Proposed changes to the ECSS-E-ST-50-15C standard

Torbjörn Hult

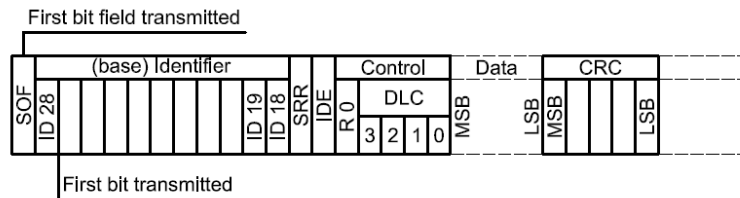
- Clause 5.3.3.1 specifies that “Transceivers shall withstand a voltage in the range between -10V and +15V on their bus pins w.r.t to chassis ground.”
- The heritage from ISO 11898-2 is that the bus can be shorted to a 12V battery voltage. No other ECSS standard requires such tolerance.
- The rationale is that “those numbers envelope possible performances from present and future ISO and RS-485 transceivers”
- The proposal is to reduce the levels to something that is in line with other ECSS standards, like -3V to +8V. This is and allows for using for instance other transceivers in the future.
 - Fault voltage tolerances are normally tightly coupled to the ground potential difference between the units connected to a link/bus
